DS90UH941A-Q1 (PG1.0) vs DS90UH941AS-Q1 (PG2.1) Device Comparison

This document describes differences between DS90UH941A-Q1 (PG1.0) and [DS90UH941AS-Q1 \(PG2.1\)](#) devices.

Appendix I: PDS90UH941A-Q1 PG1.0 Prototype Device Errata

Figure 1. Power Supply Sequencing Diagram

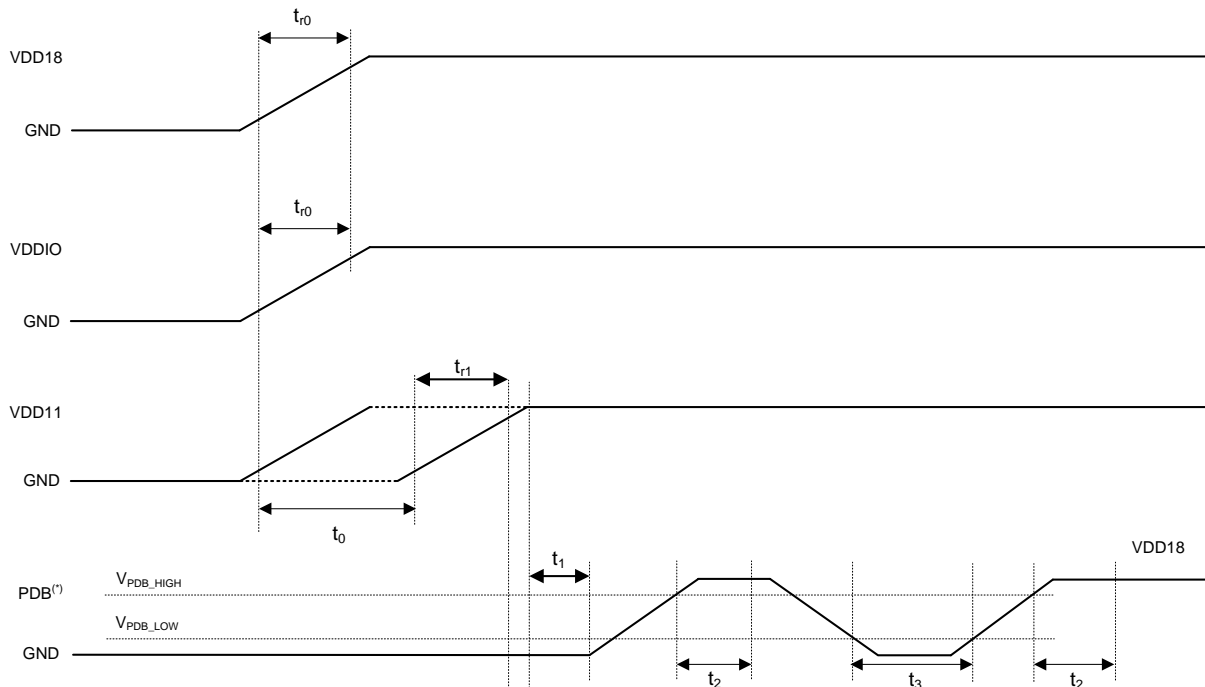
(*) It is recommended to assert PDB (active High) with a microcontroller rather than an RC filter network to help ensure proper sequencing of PDB pin after settling of power supplies.

Figure 2. Initialization Sequencing Diagram

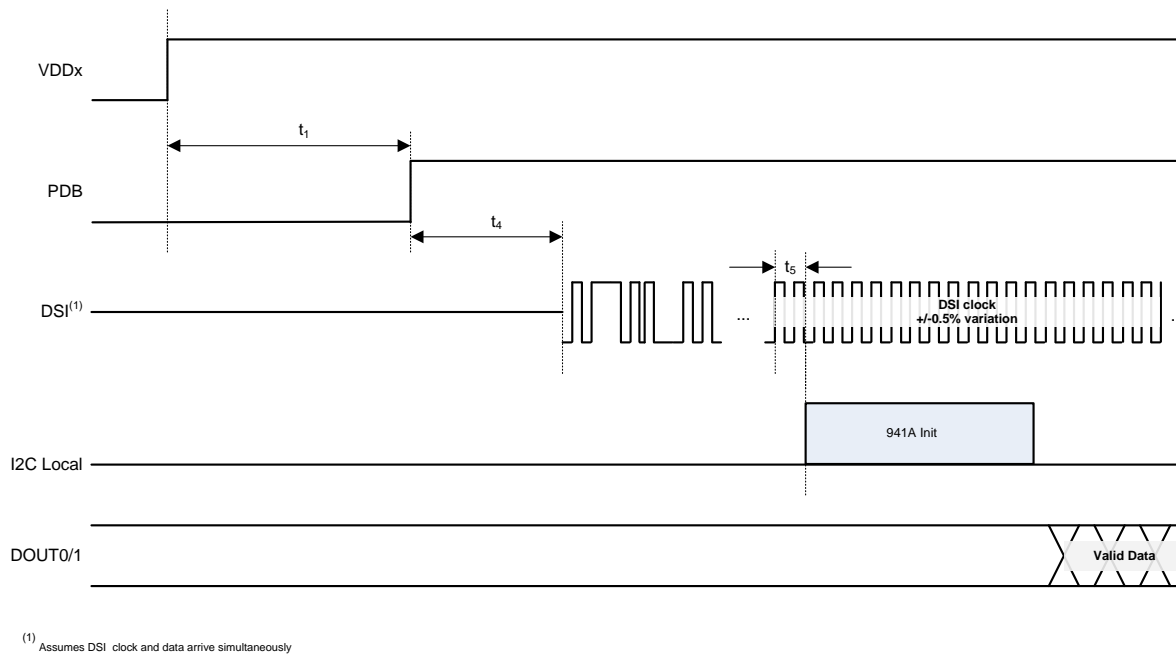
Description: In rare instances, the system display can show a pixelated mixed-color screen at power up if the DS90UH941A device is brought out of reset while the input DSI clock is still unstable. Note this symptom has a very low occurrence rate (in the region of $\sim 1/1000$ power cycles).

Workaround: Initialize the device after DSI CLK has stabilized as shown in Figure 2.
